1.0 APPLICATION SUMMARY

Applicant: Florida Health Sciences Center Inc.
 FLU Category: UMU-20
 Service Area: Urban/TSA
 Site Acreage: +/-5.27 acres
 Community Plan Area: Brandon
 Overlay: None
 Request: Minor Modification to PD 97-0259

APPLICATION NUMBER: PRS 25-0013

2.4 Existing Site Plan (Partial)

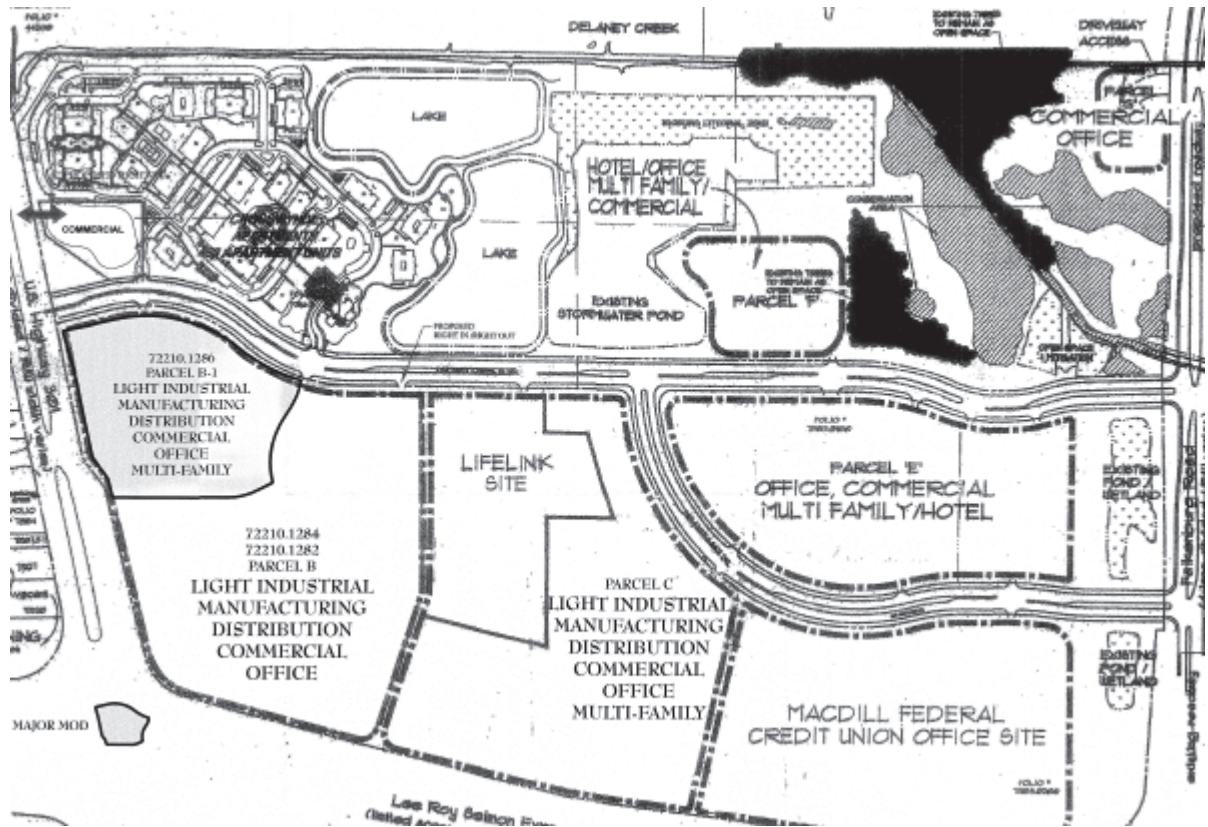
(1) Condition 7 allows a maximum of 20 dwelling units per acre in Parcel F.

Land uses, setbacks, and other development standards within areas to be developed as "Multifamily residential" (Parcel A, Parcel B-1, Parcel E, Parcel C and Parcel F) shall be restricted to those permitted within the RMC-20 zoning district except the maximum height shall be 100 feet. The maximum density shall be 20 dwelling units per gross acre.

2.5 Proposed Site Plan

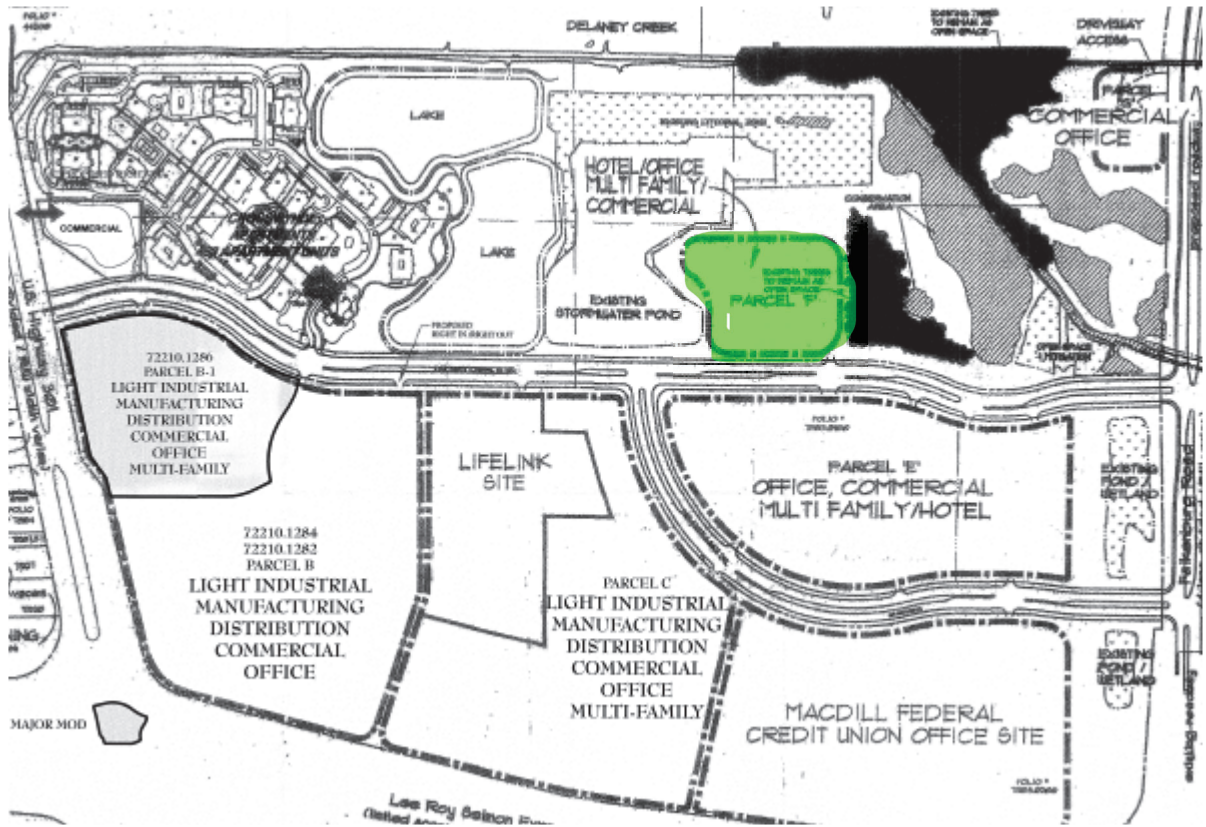
(1) Modify Condition 7 to allow a maximum of 170 multi-family dwelling units and an accessory childcare facility on Parcel F.

The applicant proposes to amend condition #7 to allow an increase of multi-family dwelling units on +/-5.27 acres designated Parcel F.

Land uses, setbacks, and other development standards within areas to be developed as "Multifamily residential" (Parcel A, Parcel B-1, Parcel E, Parcel C and Parcel F) shall be restricted to those permitted within the RMC-20 zoning district except the maximum height shall be 100 feet. The maximum density for Parcel A, Parcel B-1, Parcel E, and Parcel C shall be 20 dwelling units per gross acre. Parcel F may have up to 170 dwelling units, and also a child care center. The 2-for-1 additional setback for structures over 20 feet in height requirement shall not apply in Parcel F.
